Subject: **Proposal for revision of the timing tables and definitions in SPI-4**

This proposal utilizes the timing budget already accepted into SPI-4 and completes the homework to use the timing budget as the basis for modifying the related timing tables, definitions, and figures.

This proposal includes two alternative methods for timing tables along with explanatory figures to illustrate the basic differences in the alternatives. T10 will need to peruse the alternatives and pick the one or ones they are more comfortable with. Rev 1 adds Figure 53 input for Fast 160.

Fast-160 Simplified timing

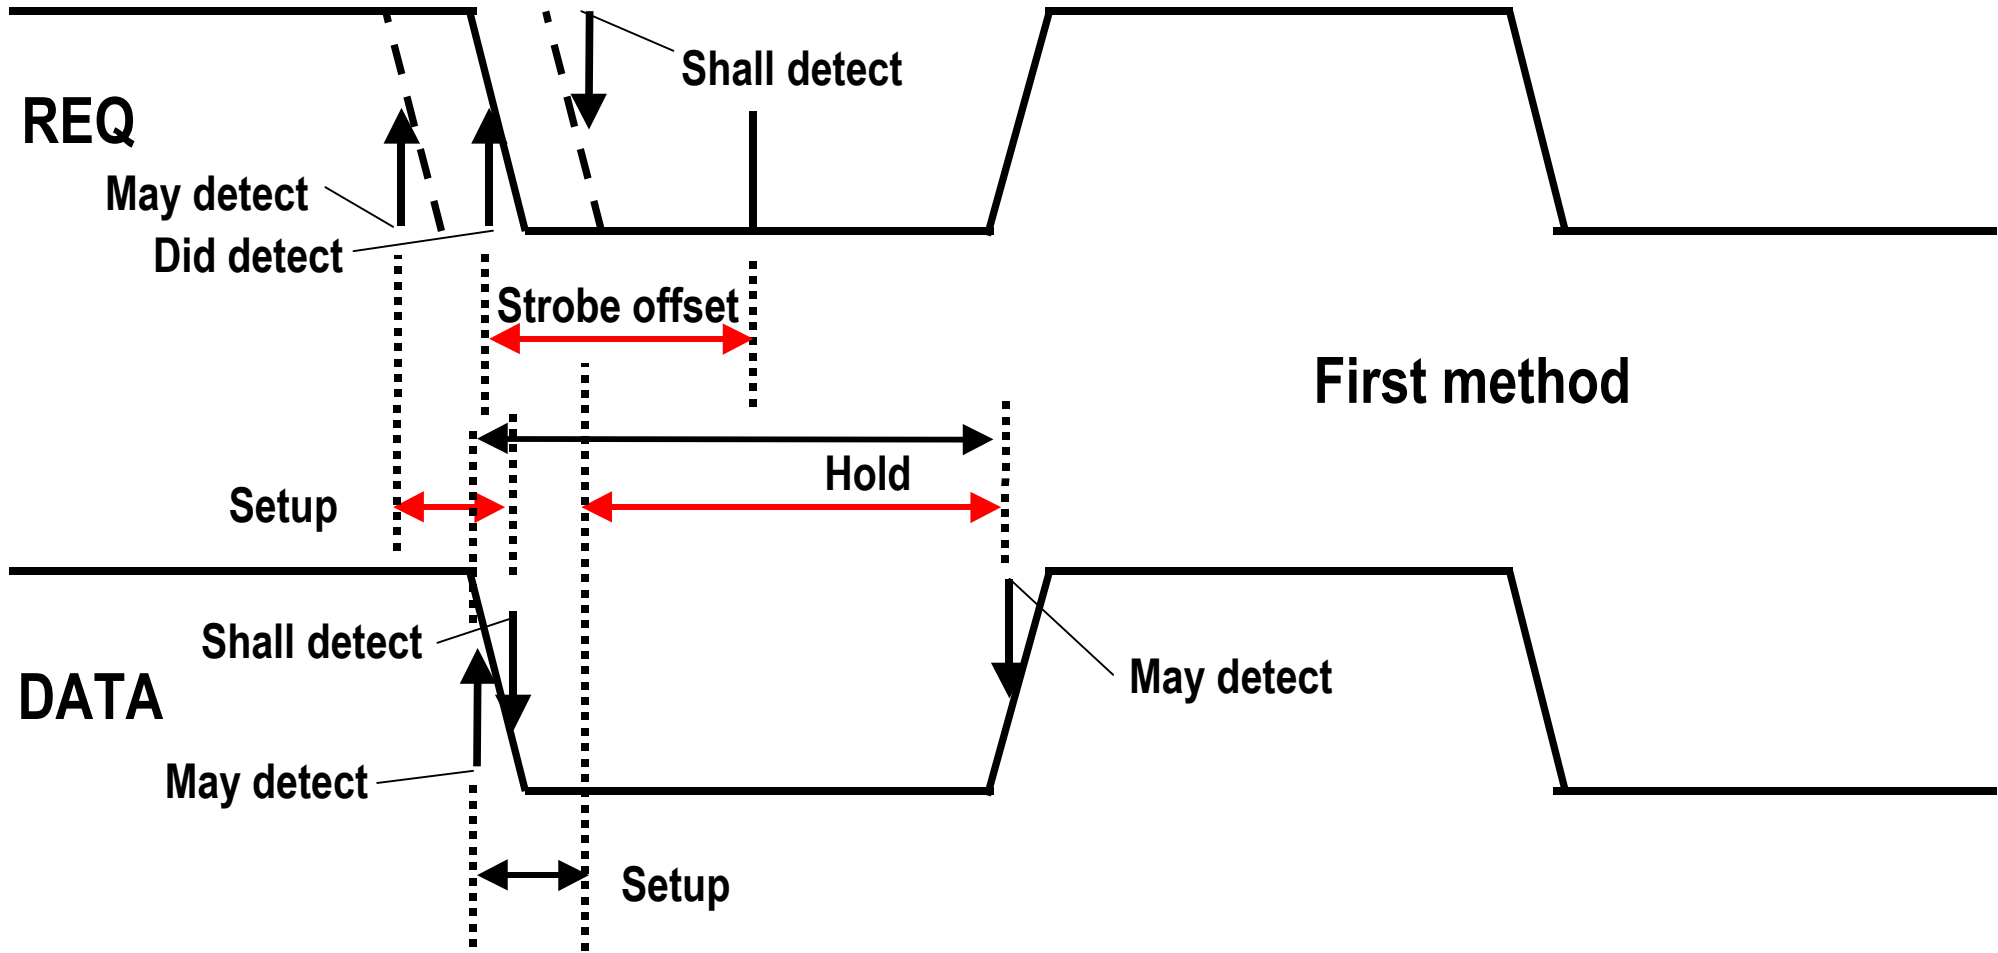
(First Method is with timing specifications as measured at the SCSI bus connector.)

Potential new table SCSI bus data & information phase DT timing values (Fast-160 Second Method is with setup and hold timing specifications as if after deskewing and strobe offset.)

Application of timing budget - skew block diagram F160 ala Fig 53

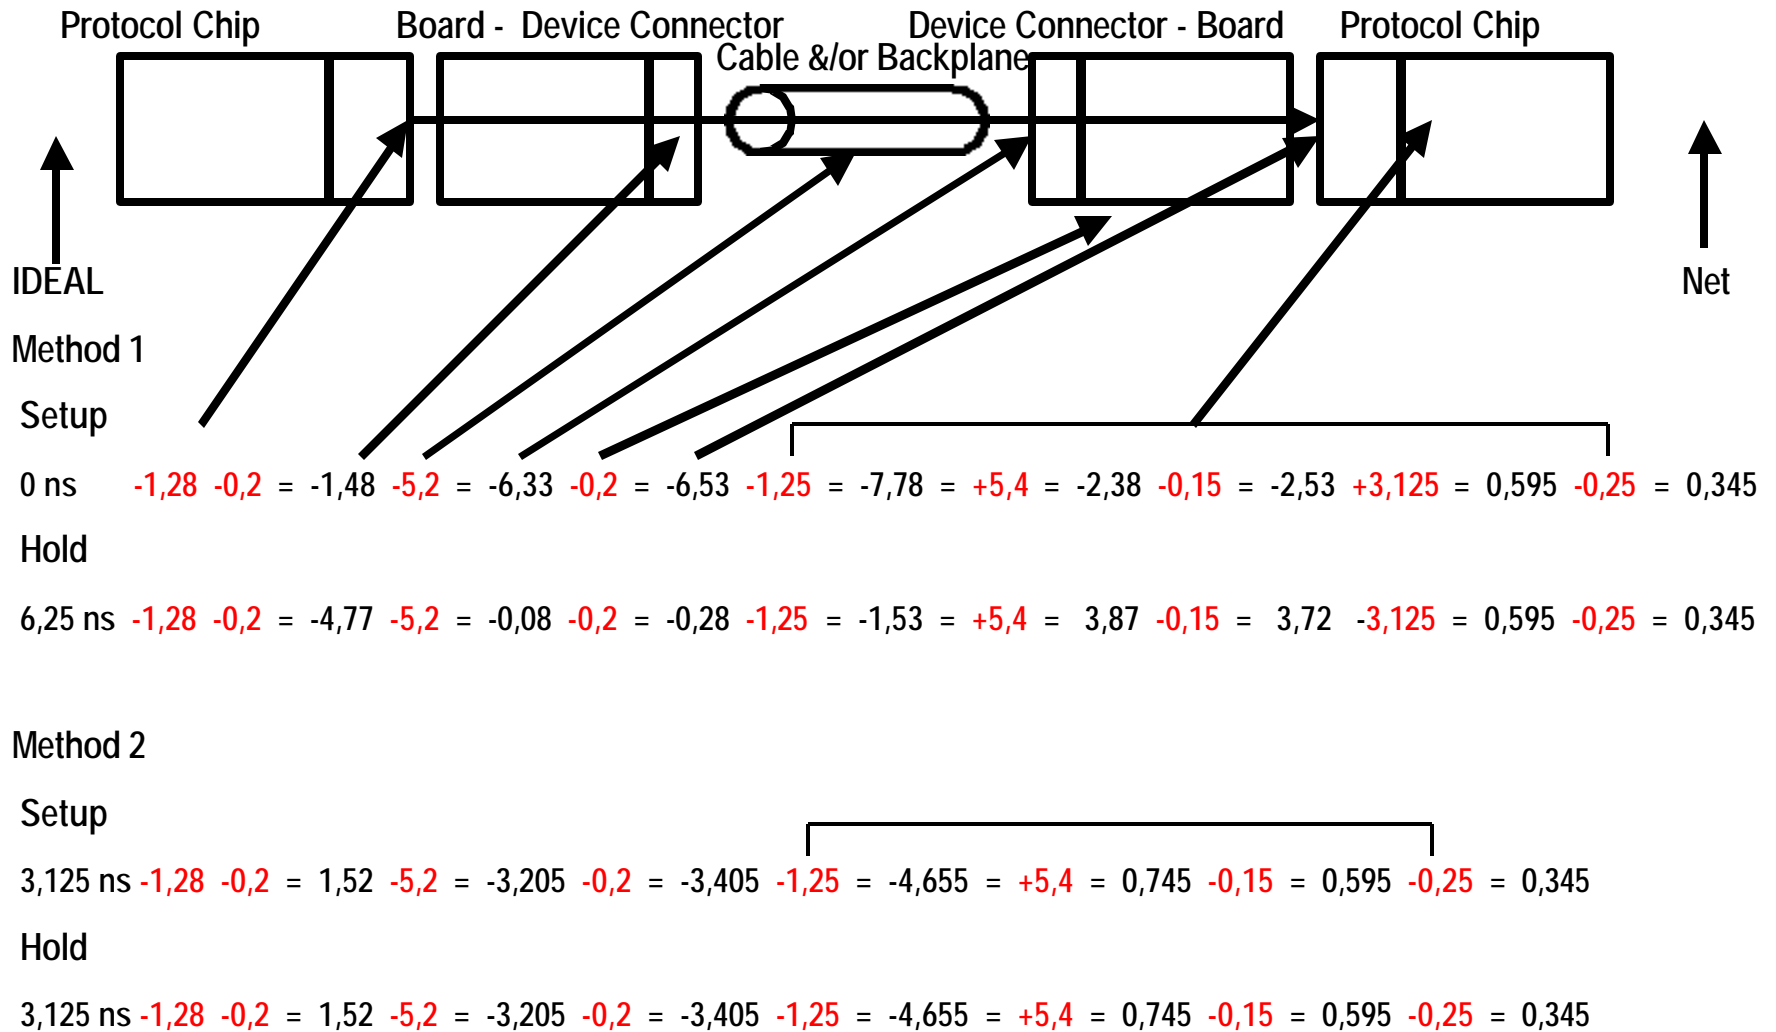
- Board skew
- Receiver amplitude skew
- Receiver chip skew
- Receiver assymetry
- System noise at the receiver
- Receiver chip noise (applied at receiver due to small signal physics)
- ISI compensation (Should we have two diagrams - one with this in transmitter and one with it in receiver?)
- Skew compensation
- Strobe offset tolerance
- Residual skew error
